WARSON ROAD IMPROVEMENT PROJECT
FEDERAL PROJECT NUMBER STP-5526(640)
CITY OF CREVE COEUR, MISSOURI

ADDENDUM #2
JANUARY 19, 2018

PROJECT SUPPLEMENTAL SPECIFICATIONS

SIDEWALK HANDRAILING WITHOUT BALUSTERS

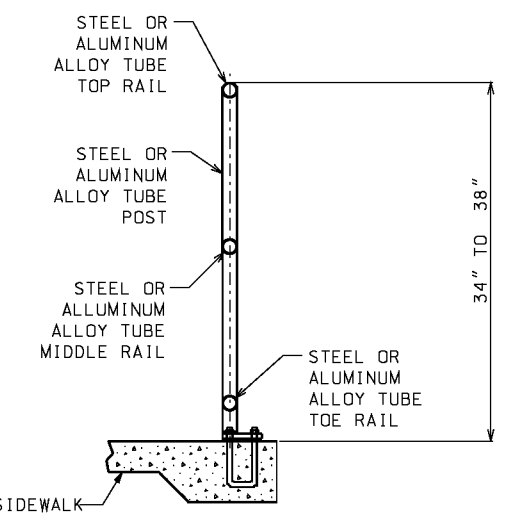
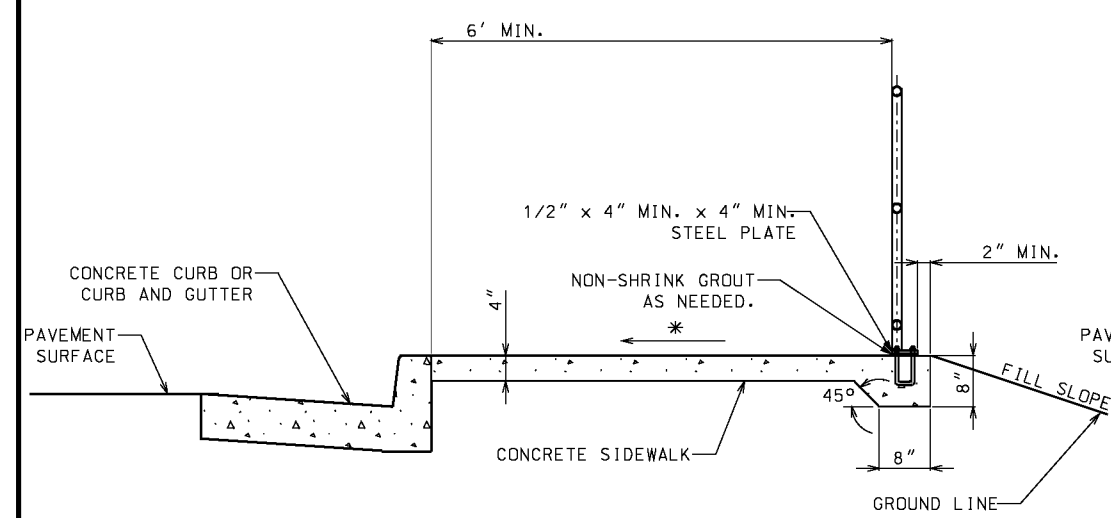
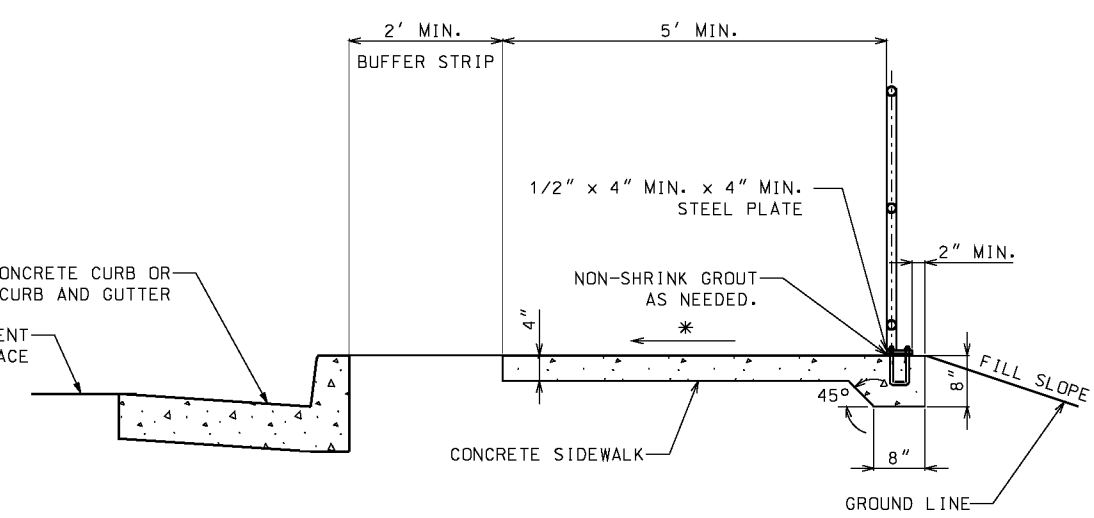
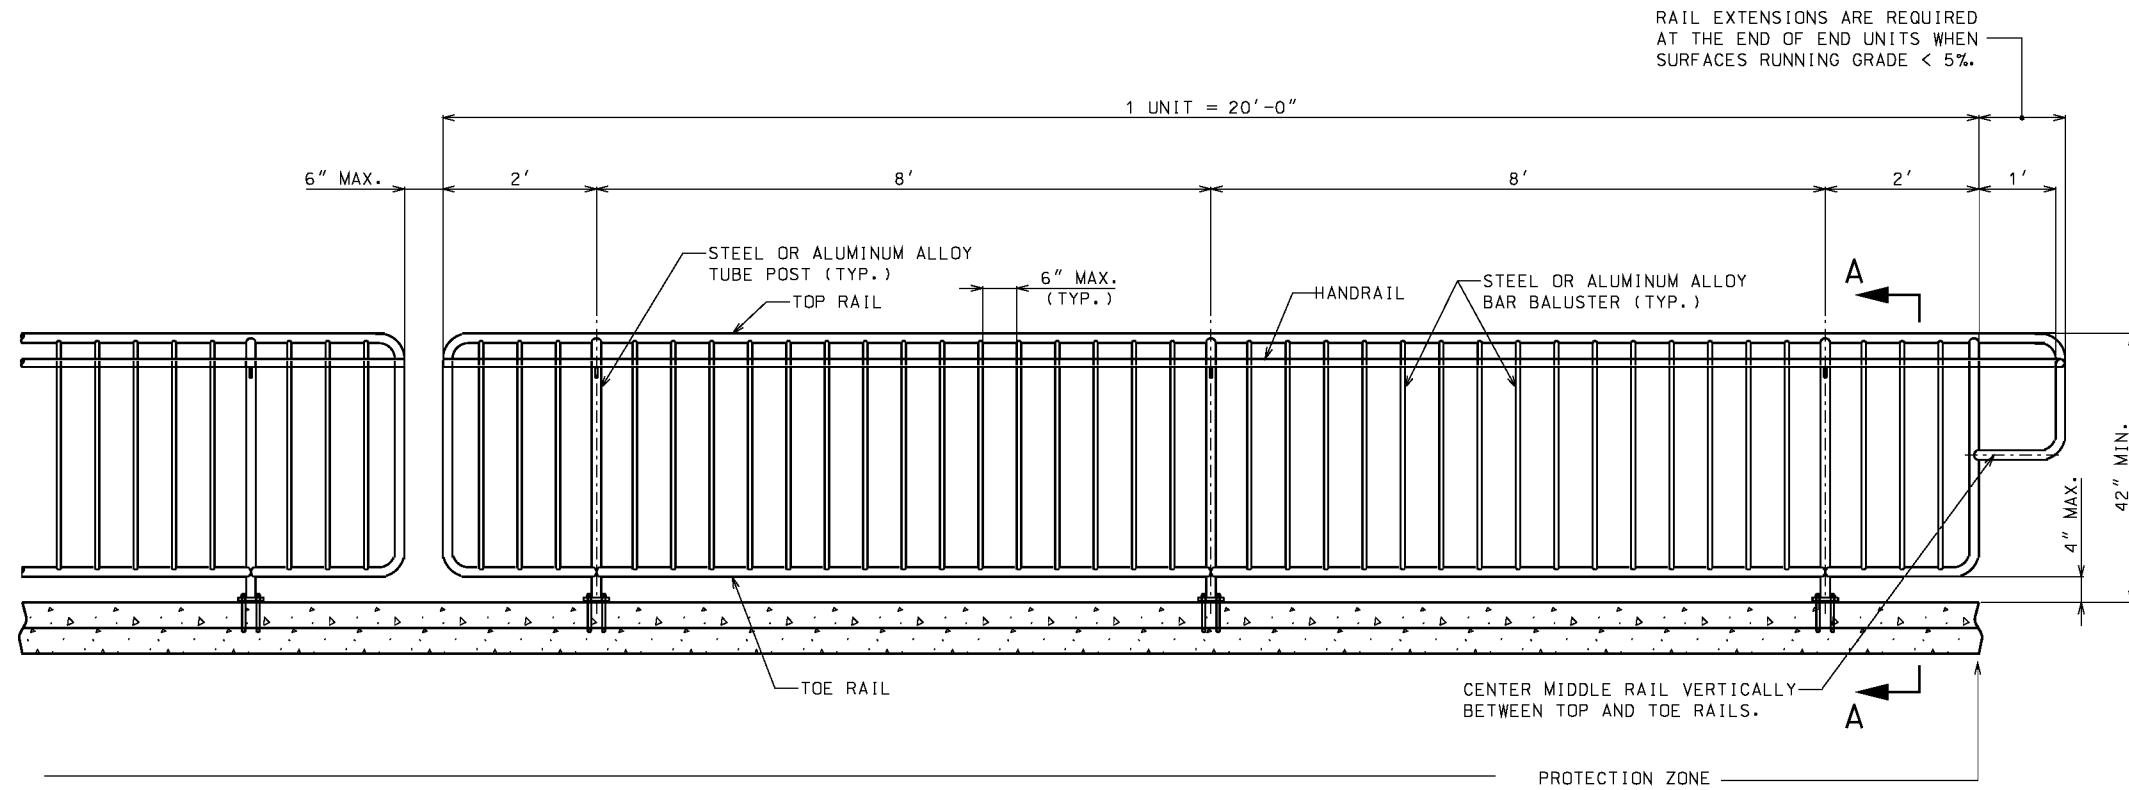
Item #1: Aluminum Handrail. The scope of work required for Item 607-30.25 "Aluminum Handrail" has been revised to be an ADA-accessible handrail according to Missouri Standard Plans for Highway Construction Standard Number 608.40 and shall be powder coated black.

Aluminum Handrail shall be according to the materials and dimensions of “Sidewalk Handrailing Without Balusters,” as shown in Standard Plan 608.40 Handrailing of the Missouri Standard Plans for Highway Construction.

Aluminum Handrail shall be mounted to the edge of the sidewalk, either by socket or by plate, according to the details of Standard Plan 608.40. The edge of the sidewalk shall be constructed to be thicker at the base of the Aluminum Handrail, as shown on Standard Plan 608.40.
